STATE OF NORTH CAROLINA
DEPARTMENT OF TRANSPORTATION

Addendum No. 1

RE: **DD00446**
Nash County

TYPICAL SECTION NO. 4
MAP # 7

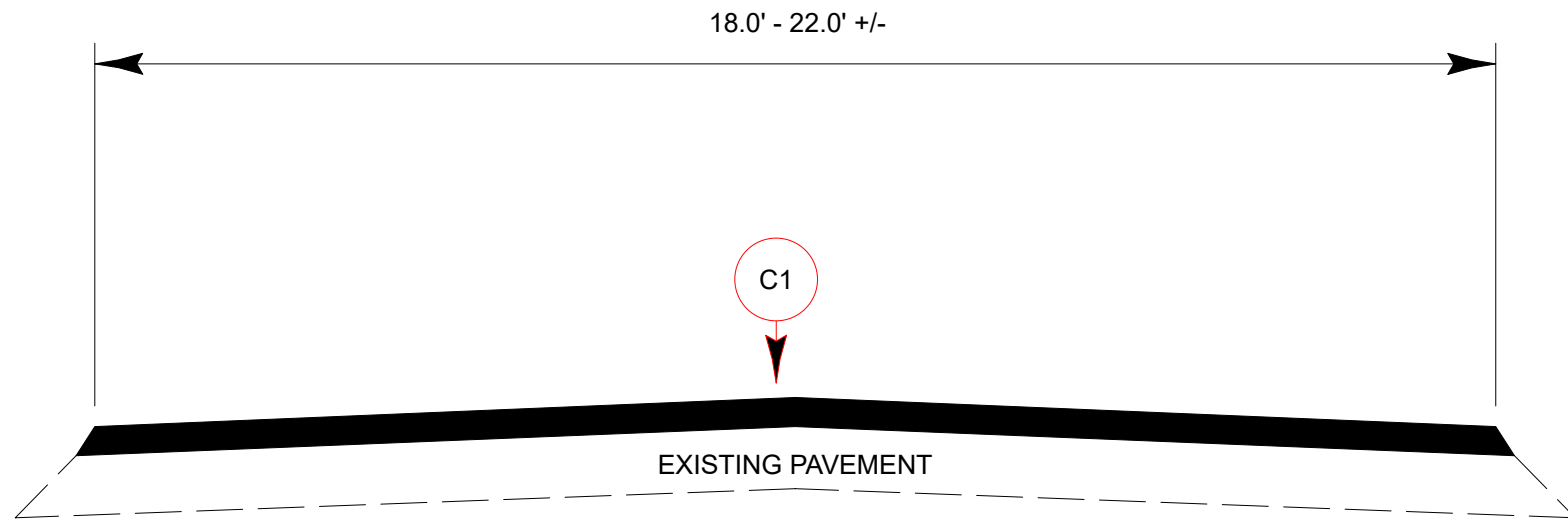
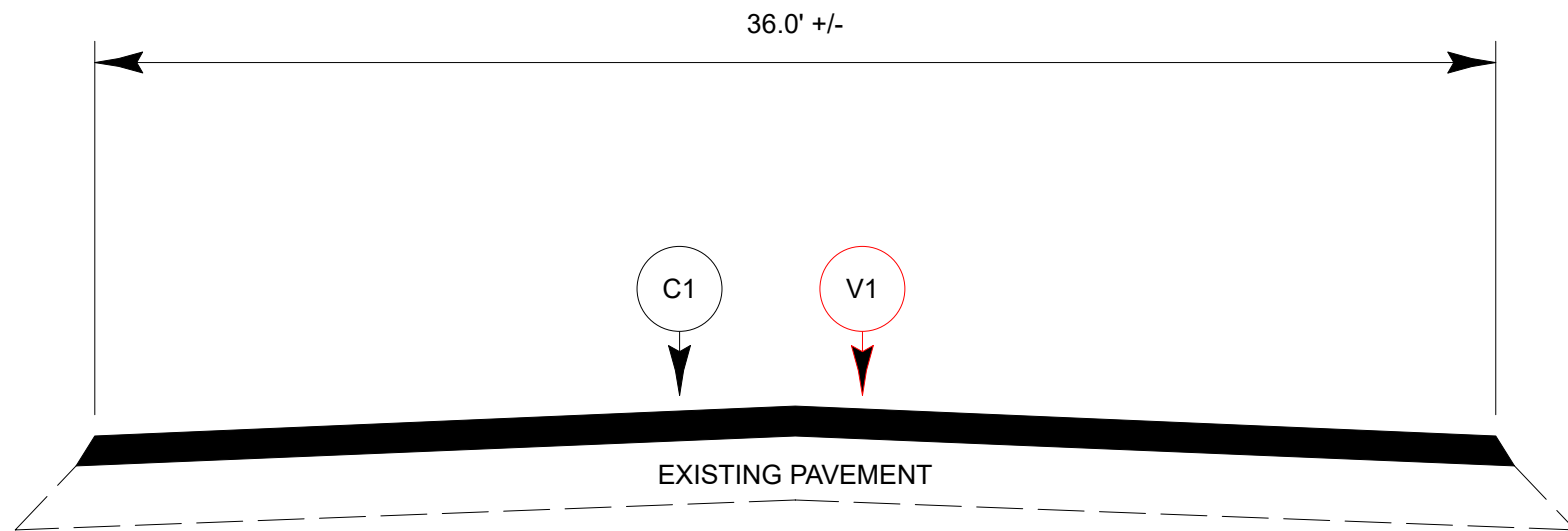
1. Typical Section No. 4 on page 37 of the proposal incorrectly shows I19.0C. This Typical should show 1.5" Milling with 1.5" of S9.5B. Please replace the Typical Section page 2 of 2 in the proposal with the attached page.
